**Office of Enterprise Assessments
Assessment of Safety System Management at
the Savannah River Site H-Canyon Facility**

January 2019

**Office of Nuclear Safety and Environmental Assessments
Office of Environment, Safety and Health Assessments
Office of Enterprise Assessments
U.S. Department of Energy**

Figure 3: Fan Motor Clutch

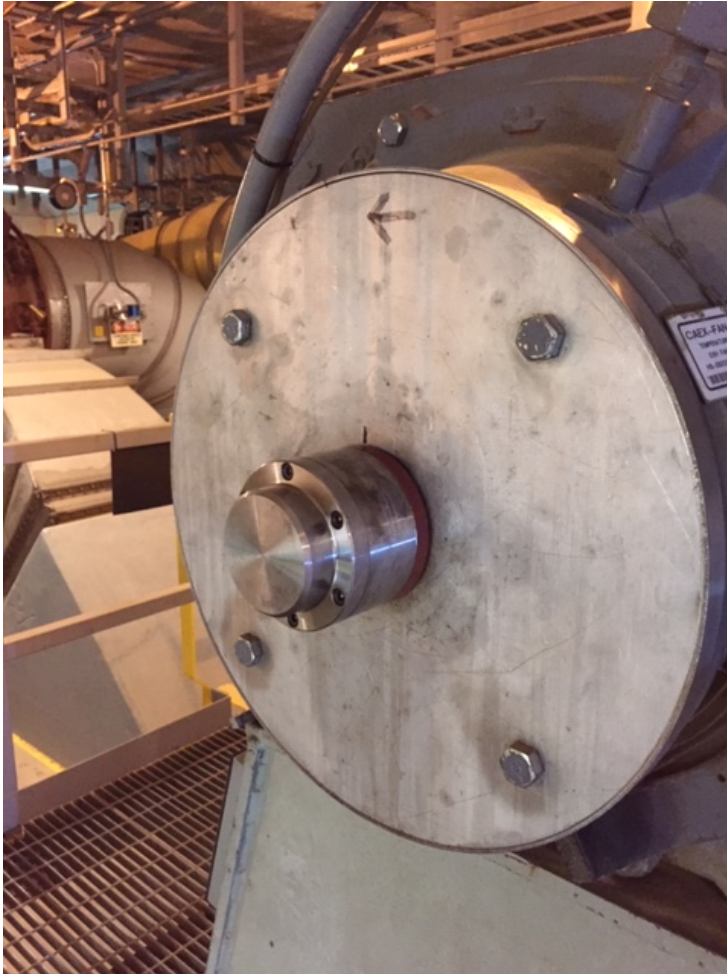
While reviewing these conditions, EA identified a functional requirement document, E-FPR-G-00005, *Functional Performance Requirements Upgrade Canyon Exhaust System*, requiring this updated system to meet the single failure criteria from DOE Order 6430.1A, Section 1300-3.3, *Single Failure Criterion and Redundancy*. Compliance with these requirements under all postulated accident and natural phenomena events could not be demonstrated without assuming functionality of the fan clutches. DOE-STD-3009-94, *Preparation Guide for U.S. Department of Energy Nonreactor Nuclear Facilities Documented Safety Analyses*, Section 4.3.X.2, states, “Identify SSCs whose failure would result in an [SC] SSC losing the ability to perform its required safety function. These SSCs would also be considered [SC] SSCs for the specific accident conditions for which the [SC] designation was made originally.” Because the clutches are necessary to ensure operability of those fans placed in AUTO, an SC designation is appropriate. **(Deficiency)**
